MINUTES
JAMES CITY COUNTY DEVELOPMENT REVIEW COMMITTEE
REGULAR MEETING
Building A Large Conference Room
101 Mounts Bay Road, Williamsburg, VA 23185
August 22, 2018
4:00 PM

2. C-18-0064. 7083 Menzels Road Minor Subdivision

CONCEPTUAL SUBDIVISION
**MENZEL ROAD/
LITTLE CREEK DAM ROAD**
7083 MENZELS ROAD
JAMES CITY COUNTY
VIRGINIA

SCALE: 1" = 100'
DATE: 07-10-2018
JOB: 18-295
DRAWN BY: CMH
C1.00
CONCEPTUAL SUBDIVISION
01 of 01

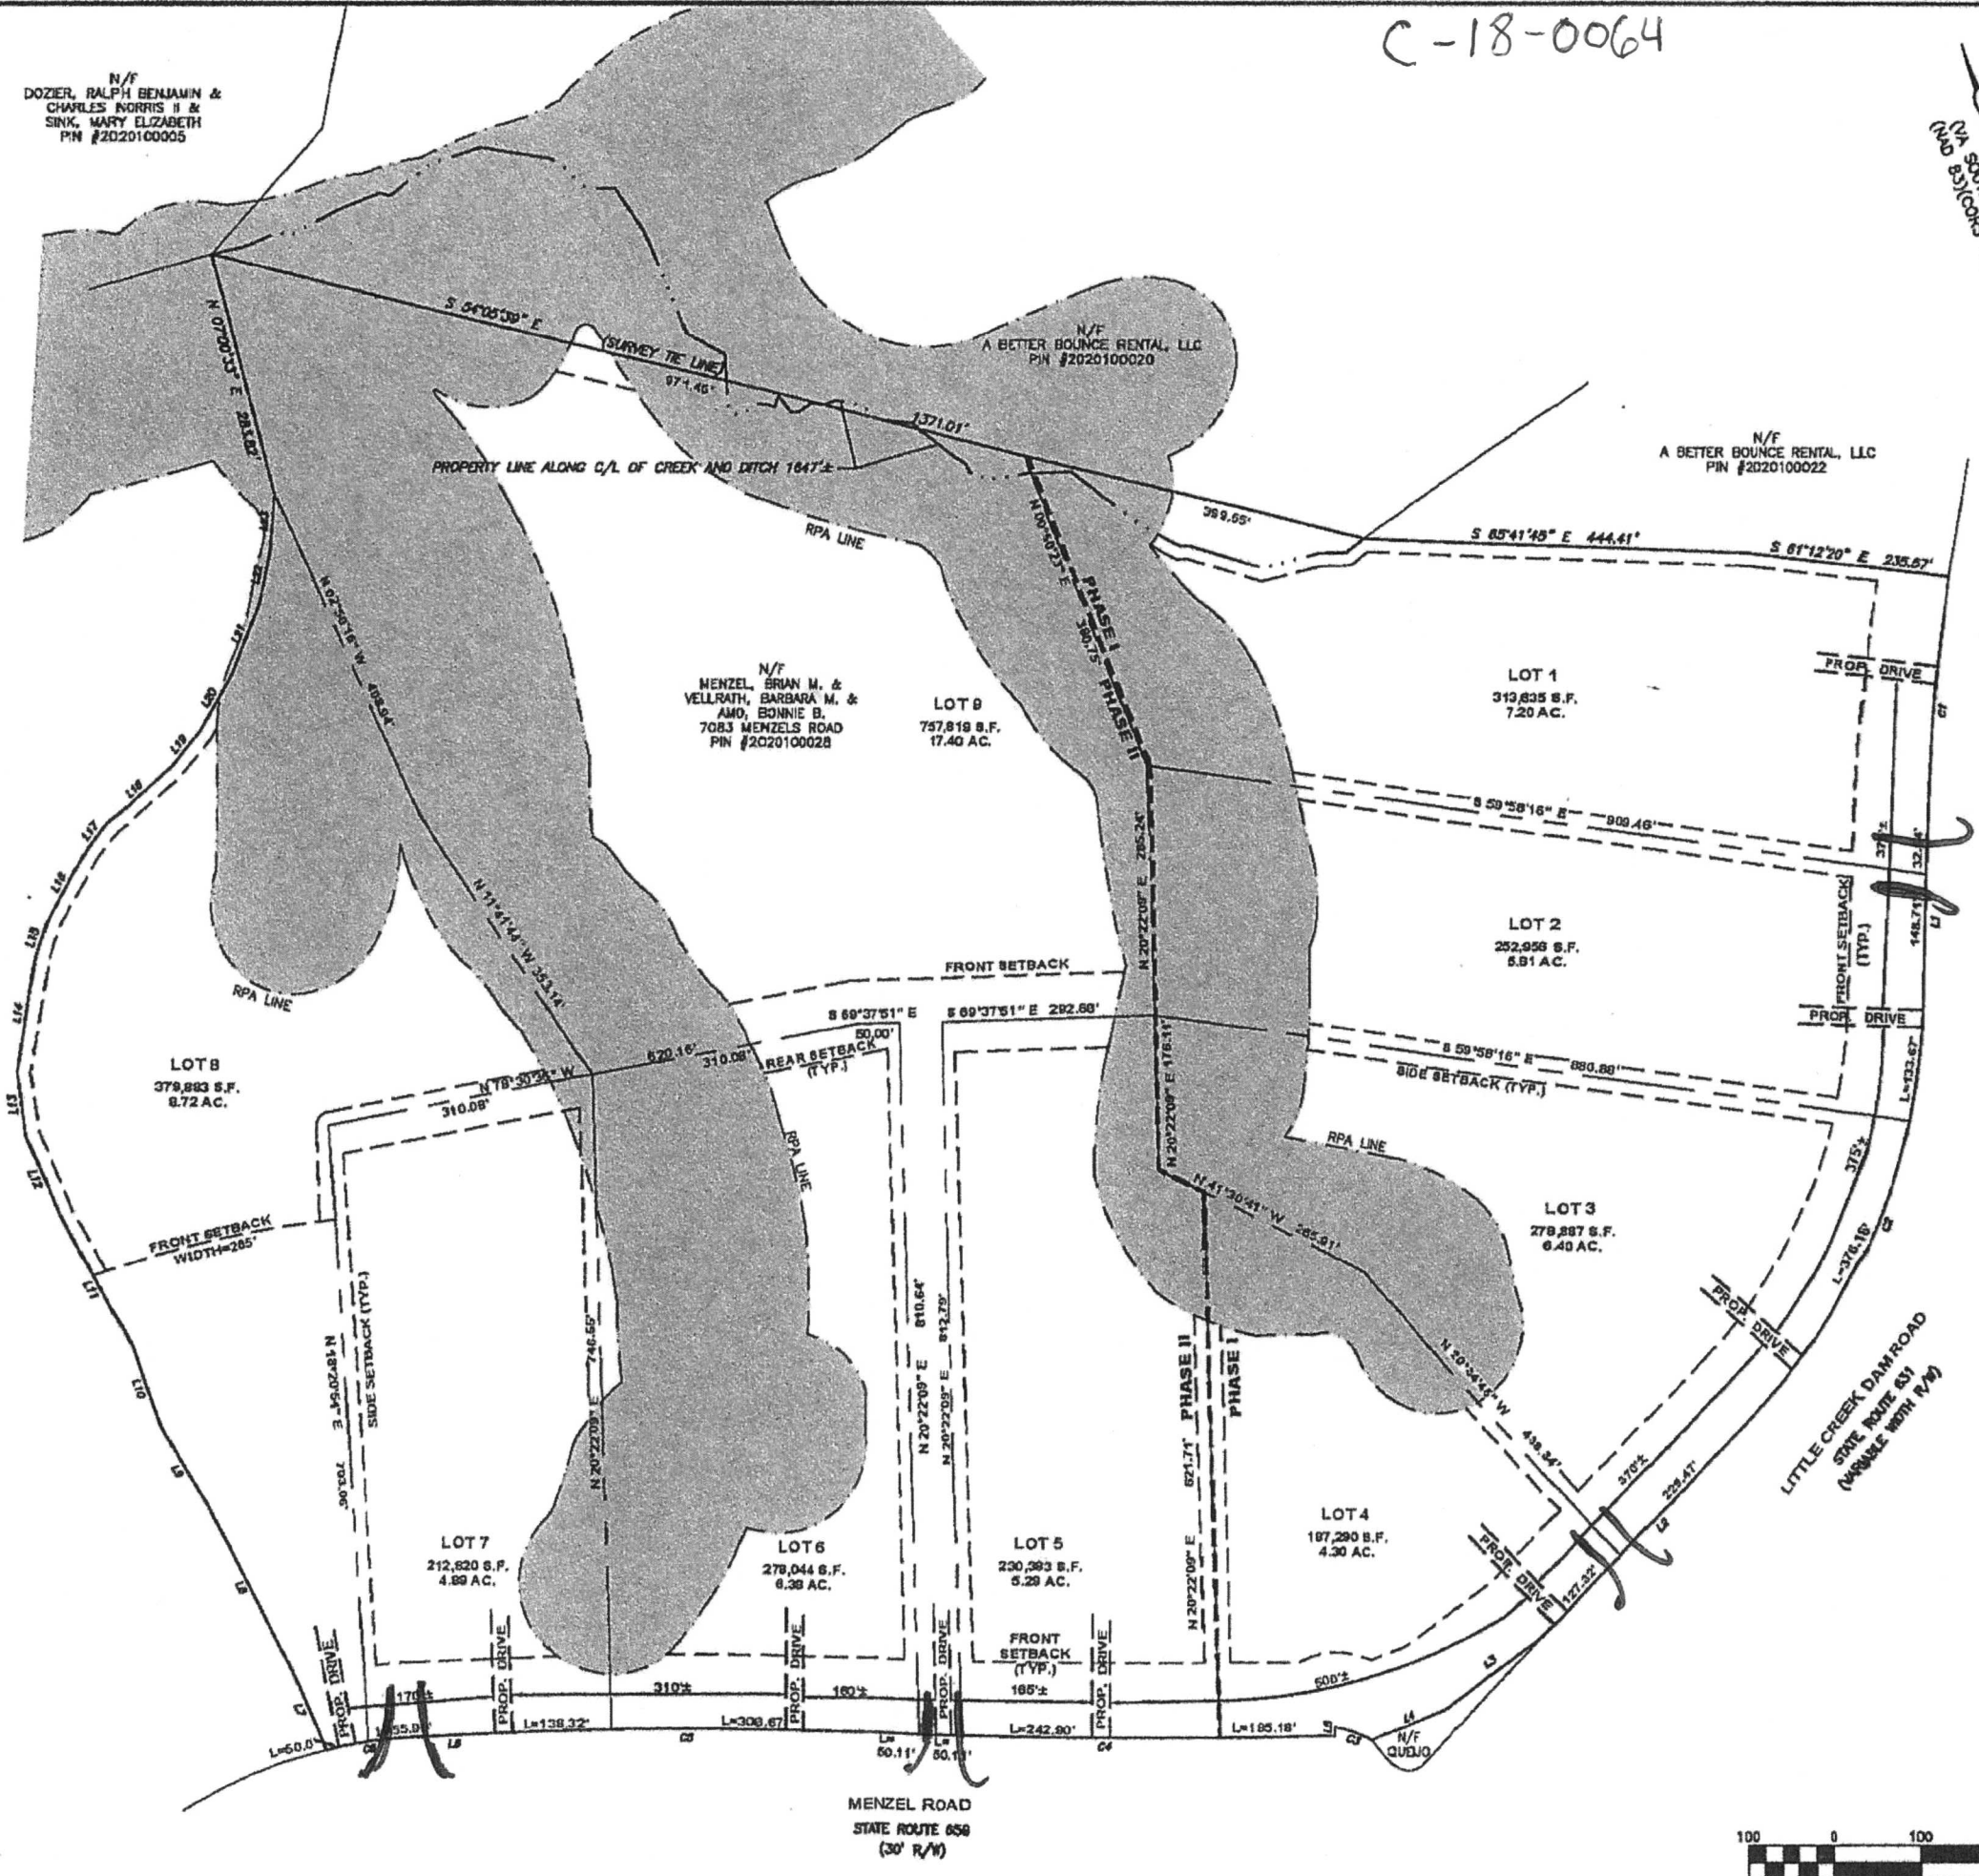
Mr. Haldeman stated that the RPA would be an issue for lots 8 and 9.

Mr. Haldeman asked if the shared driveway would service all nine lots.

Mr. Haldeman asked if the driveways were shown on the map.

Mr. Grogg stated that the shared driveways are not shown, but the individual driveways are shown.

Mr. Krapf asked if the waiver was approved, would there be a way to ensure the distance between driveways. He stated that he has concerns with any changes that would come between the conceptual stage and the subdivision plat.

Mr. Polster stated that the four shared driveways help preserve the RPA. He stated that he would like to be confident that the driveway for lots seven and eight do not enter the RPA.

Mr. Polster stated that the drainage with the driveways is a concern. He asked what the culvert design would be.

Mr. Haldeman made a motion to recommend approval to the Planning Commission of four shared driveways to serve a total of nine lots: one shared driveway serving lot nos. 1 and 2; one shared driveway serving lot nos. 3 and 4; one shared driveway serving lot nos. 5, 6 and 9; and one shared driveway serving lot nos. 7 and 8. DRC members agreed that the construction of the proposed shared driveways shall follow the construction standards of Section 19-17 of the Subdivision Ordinance and that the first 50 feet of each of the driveways shall be impervious (e.g., gravel).
